# **A12 Chelmsford to A120 widening**

Development Consent Order Change  
Application Consultation

April 2023

Updated signalisation of Old Rectory Roundabout

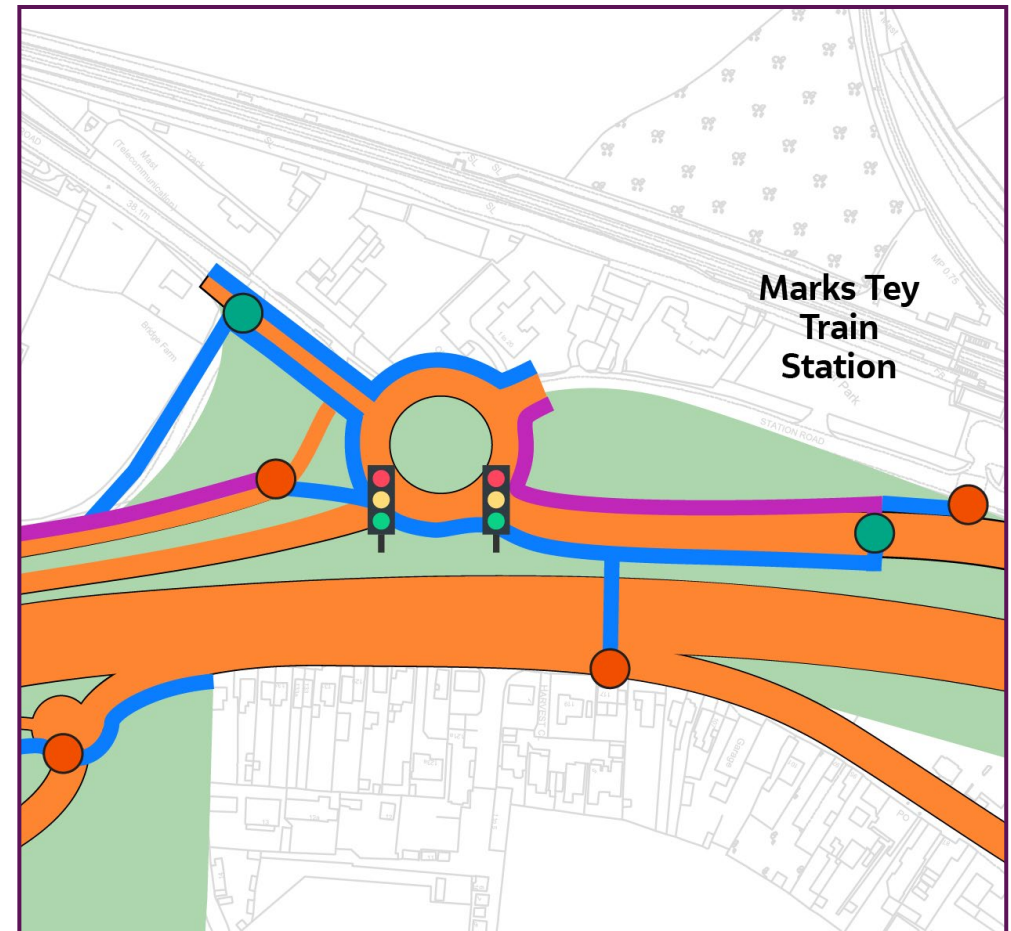
The adjacent map shows which arms of the roundabout will be signalised. The partially signalised Old Rectory roundabout is predicted to operate better than the previously planned signalised crossroads during peak hours. At quieter times of the day, the change in design also means that traffic from non-signalised arms (such as on the A120 approaching from Braintree) would be able to pass through the roundabout without the risk of having to wait at signals.
